Milwaukee Historic Preservation Commission Staff Report

Property 135 W. RESERVOIR AV. (Brewers Hill Historic District)

Proposal Front door was replaced with new door made of composite material and original sidelites were removed to accommodate a new stock sized door. A metal storm door was also installed. The work was done without a Certificate of Appropriateness.

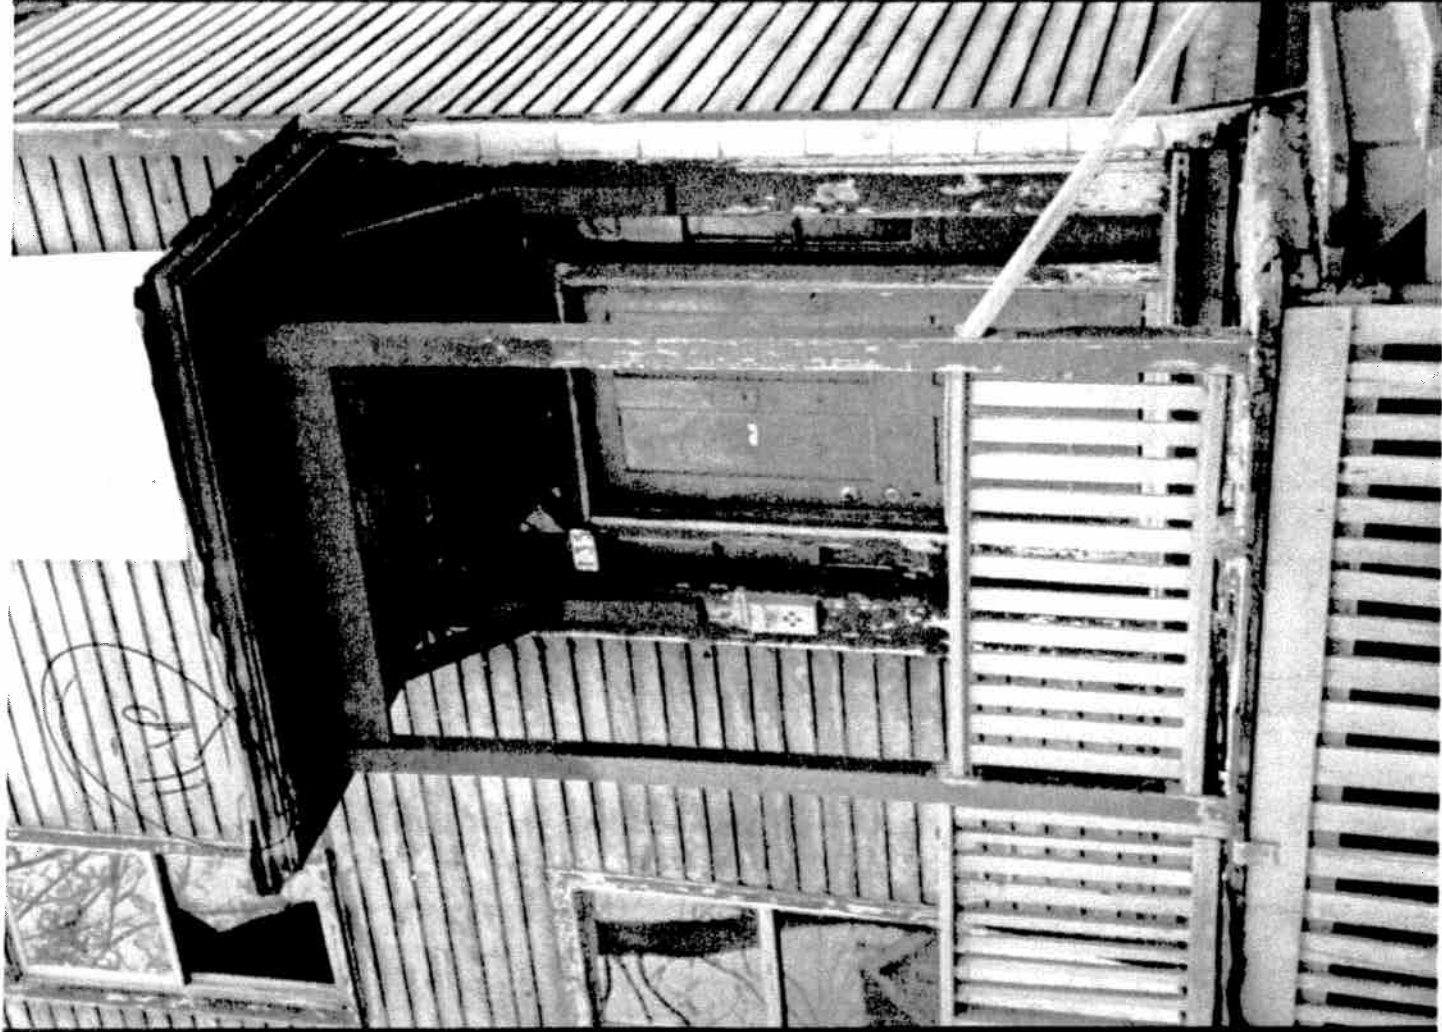
Staff comments While the exact construction date of the house is unknown, it probably dates from the 1850s or 1860s, because the original Greek Revival style door and sidelites were at their peak of popularity in Milwaukee during that time period. The old front door and surrounding framing were recently removed and replaced without a certificate of appropriateness. Following a complaint from the public, an order was issued by the Dept. of Neighborhood Services requiring the owner to obtain a COA for the work.

135 W. Reservoir

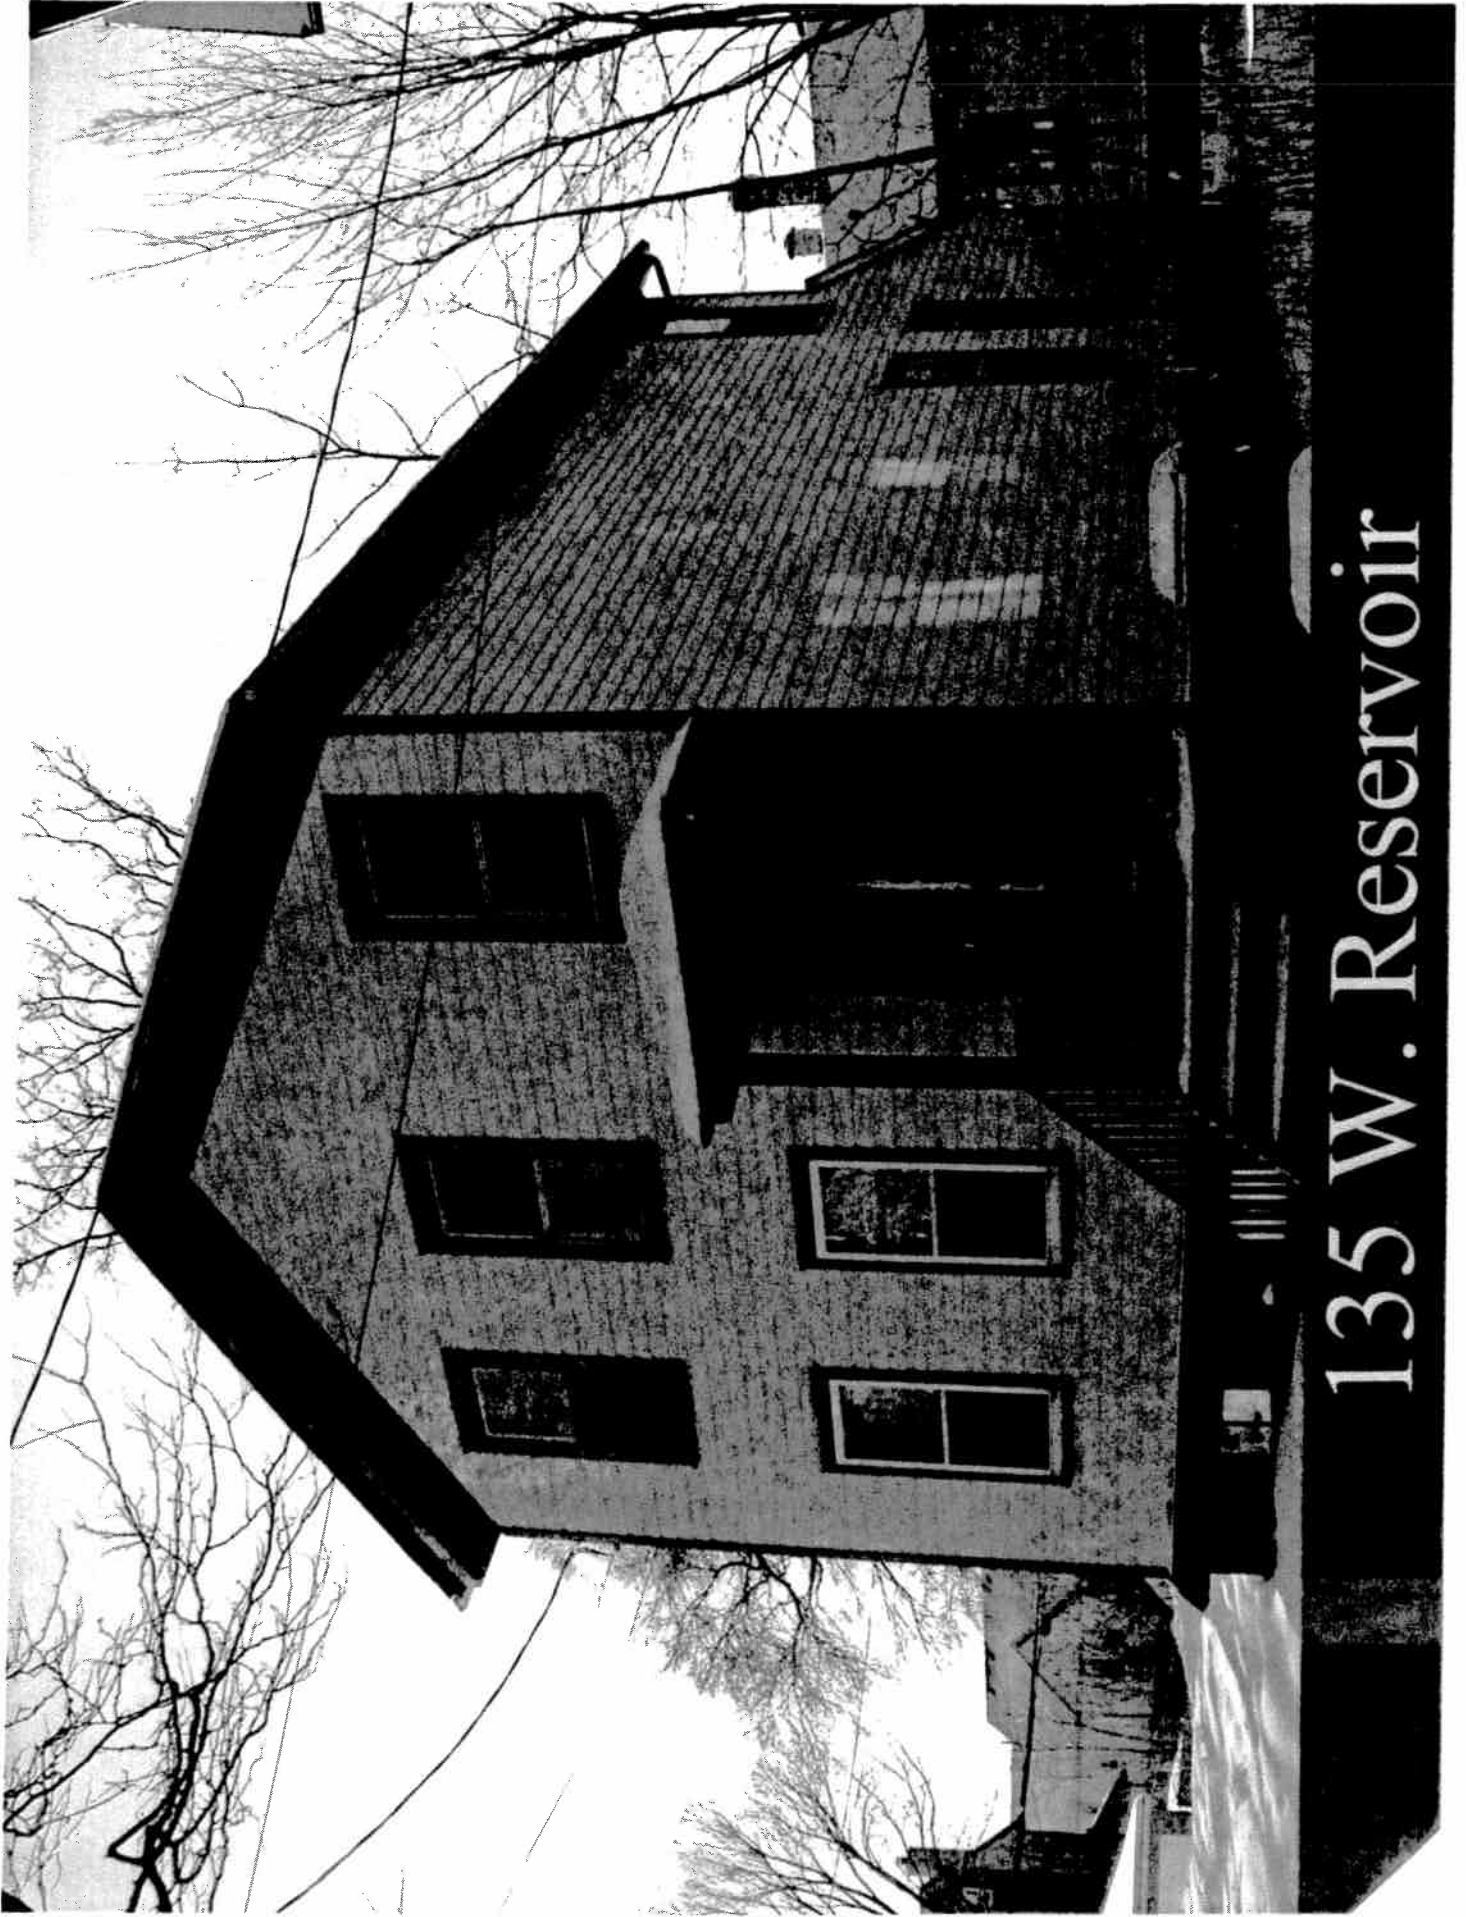
The newly installed composite material, Colonial/contemporary style door with a fanlight is a not a proper fit for the house or the Brewers Hill historic district. This type of door is expressly rejected on page 27 of Living With History, the guideline book that was mailed to all residents of historic districts several years ago. The sidelites were also removed, apparently to accommodate the installation of a new stock sized door. The removal of the old door and side lites is also contrary to the district guidelines which state: "Retain existing window and door openings that are visible from the public right-of-way. Retain the original configuration of panes, sash, lintels, keystones, sills, architraves, pediments, hoods, doors, shutters and hardware. Avoid making additional openings or changes in the principal elevations by enlarging or reducing window or door openings to fit new stock window sash or new stock door sizes... Avoid discarding original doors and door hardware when they can be repaired or reused."

There is no record in recent years of any door change out approved by HPC staff or the commission that would have permitted the installation of a composite material front door or the removal of historic transoms and side lites. In summary, because the work does not meet the guidelines, the front door surrounded by sidelites and a transom should be restored to the original size, design and configuration. In the event a storm door is required, it should be a full view wood storm door such as the one featured on page 28 of Living With History.

■ New prime door,
storm door; side
lites and transom
removed.

Recommendation Recommend HPC Denial
